RE: Modified Outfall Riprap Apron Design, Winter Quarters Sedimentation Pond, CLEAN COPIES,
Canyon Fuel Company, LLC, Skyline Mine, C/007/005, Task #6144

Title: Winter Quarters Pond Outfall Increase

Increase in the size of the Sediment Pond Outfall Structure. CLEAN COPIES Task 6411

PLAN VIEW - RIPRAP APRON
SCALE: 1"=2'

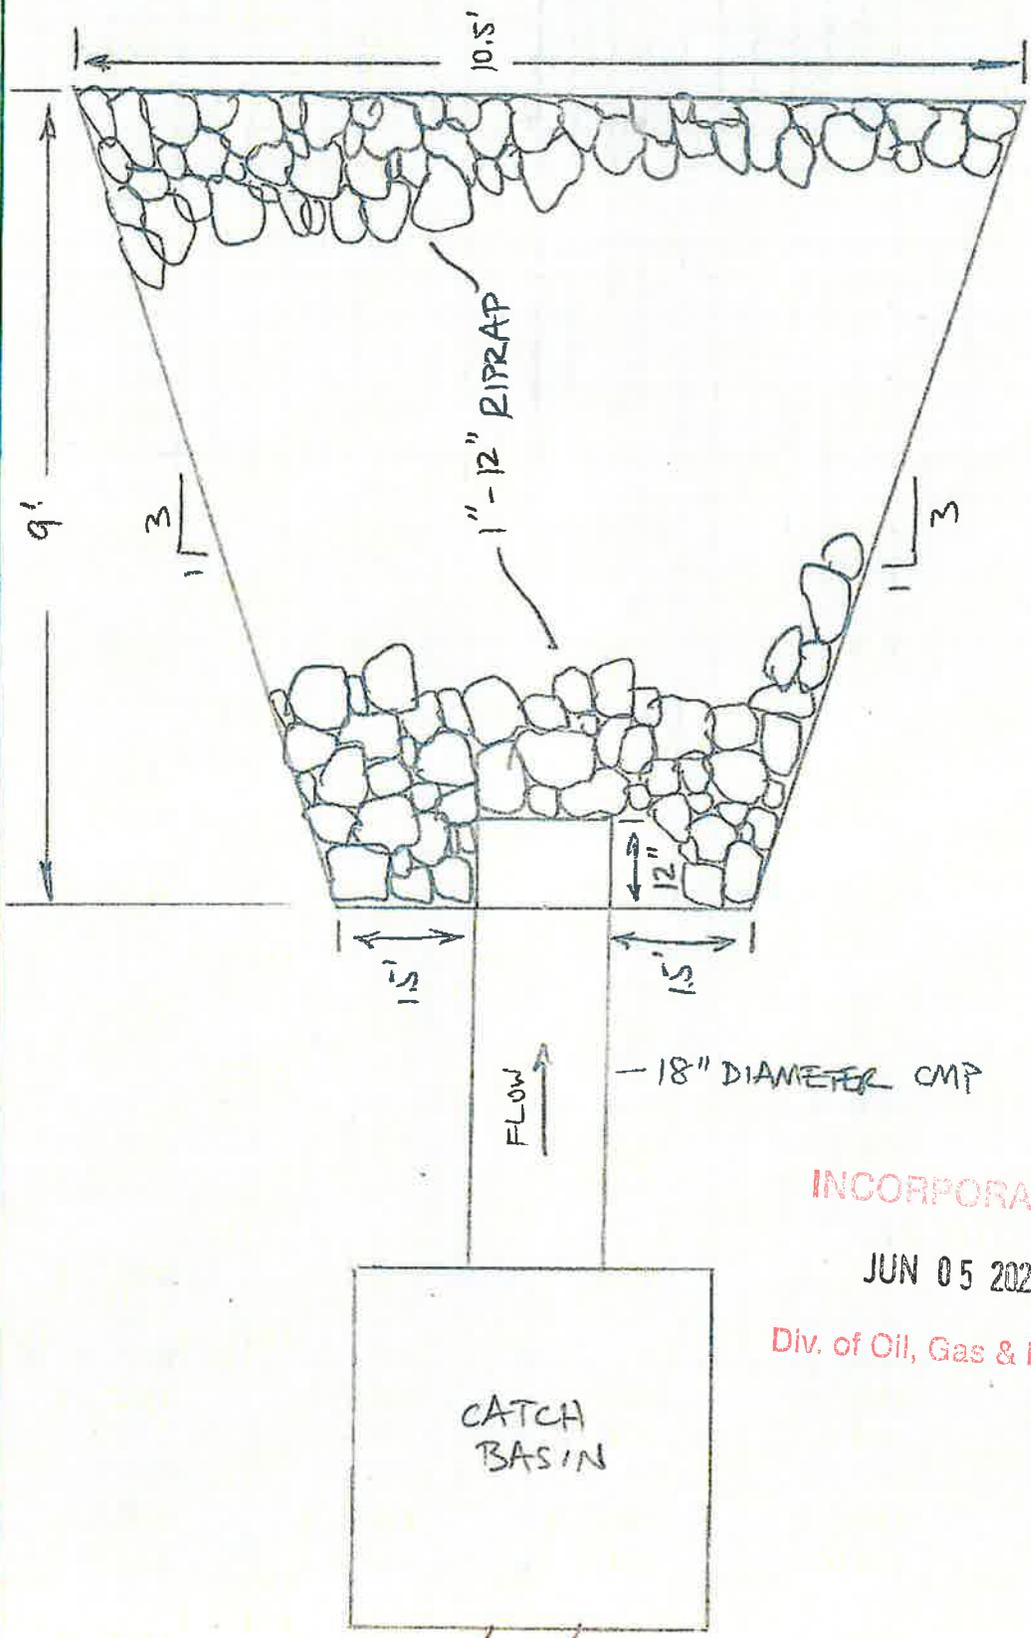
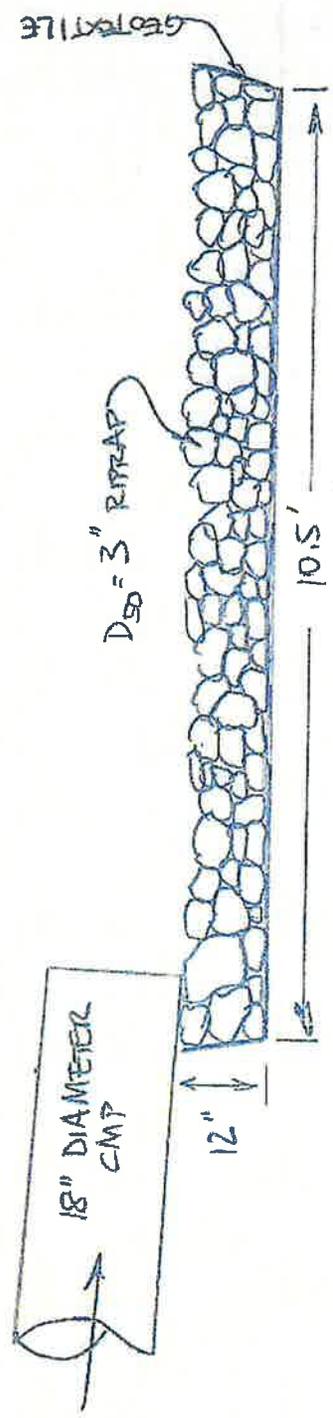
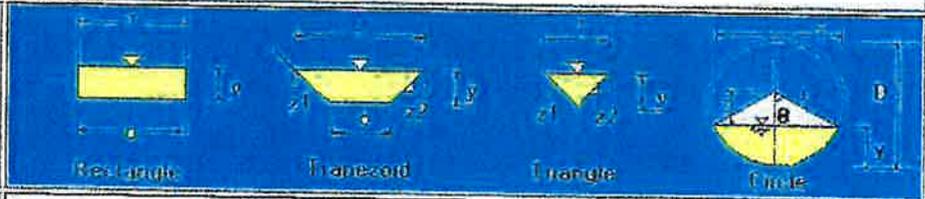
Note: Because this will be a square-ended outlet pipe, 3 ft was added to the apron length, in accordance w/ HEC-14.

P.O. BOX 719 HELIX, UTAH 84628
DATE: 12/21/11 CK.BY: CWB REVISION: 4
CAP FILE: EF-6-V0794-183.2.4-3A SCALE: AS SHOWN DR.BY: TWE
DWG. NO.: 3.2.4-3A SHEET 1 OF 9 5/11/2020

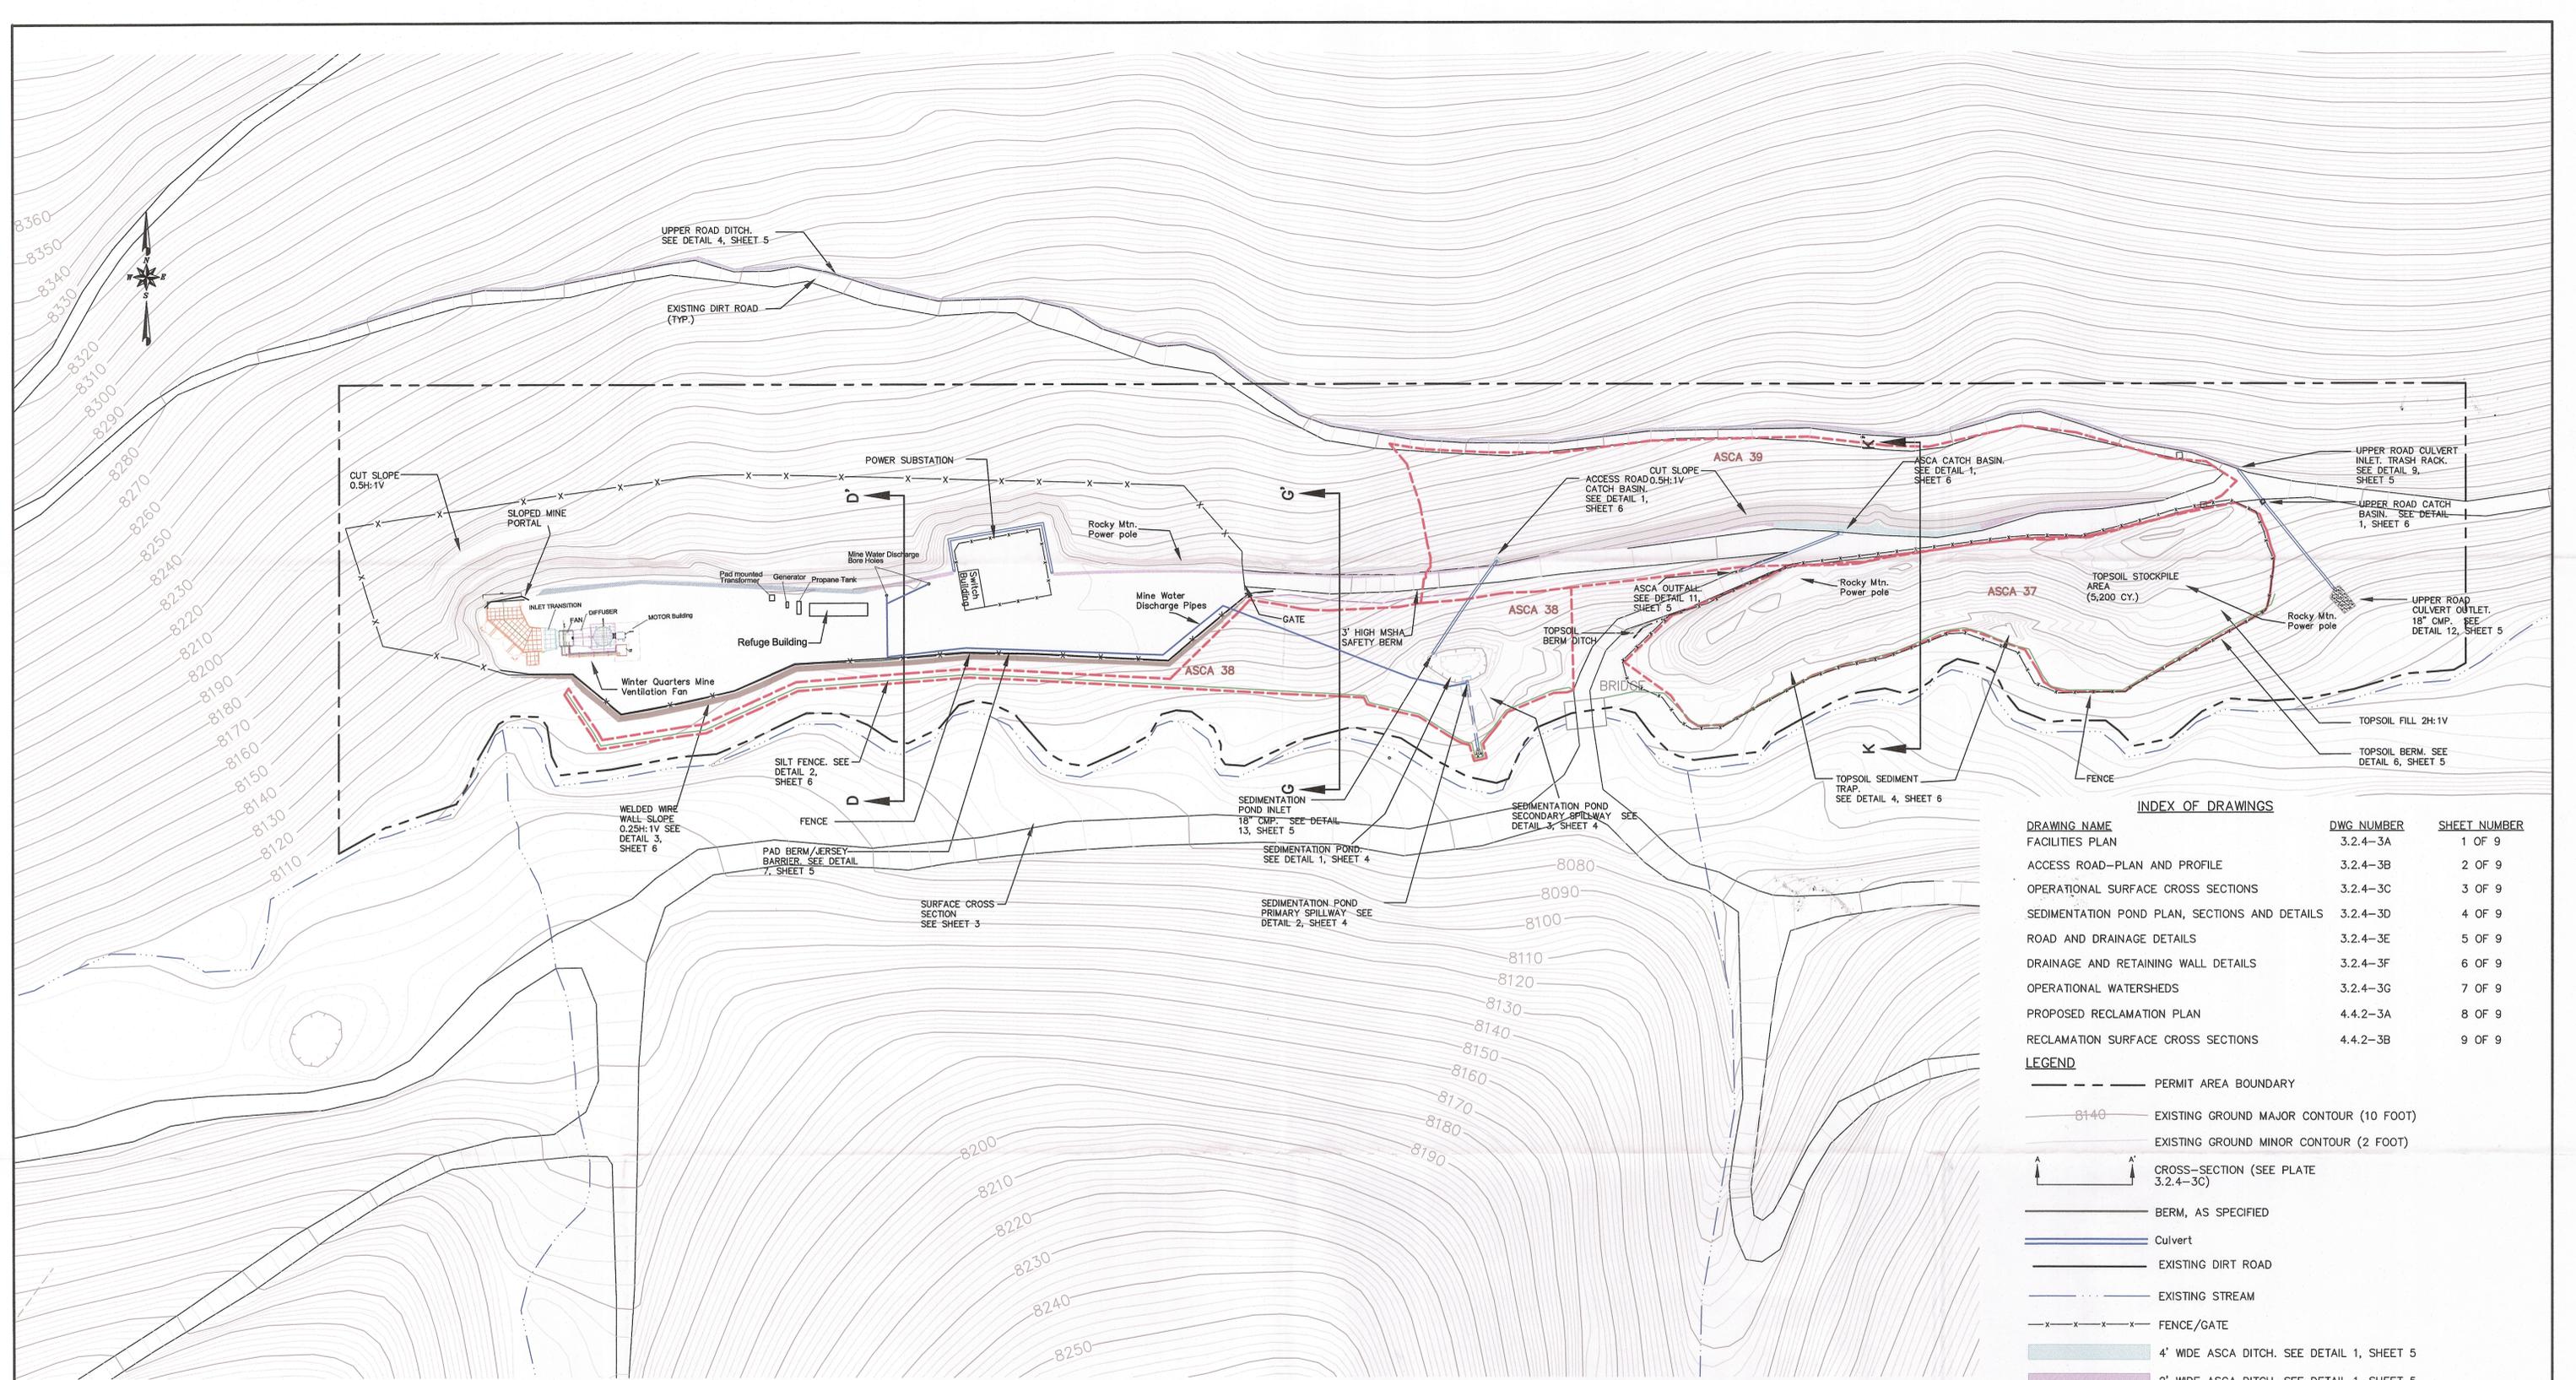
| DATE | No. | REVISIONS | Drw | Chk |
|----------|-----|---|-----|-----|
| 5-1-20 | 4 | Added mine water discharge pipe and discharge structure | TWE | GAG |

MINE DISCHARGE OUTFALL (14/5)
NOT TO SCALE

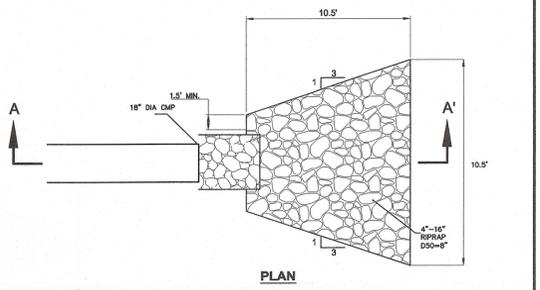
| DATE | No. | REVISIONS | TE | CW |
|-------|-----|---|----|----|
| 5/20 | 2 | Added Detail for Mine Discharge Outfall | | |
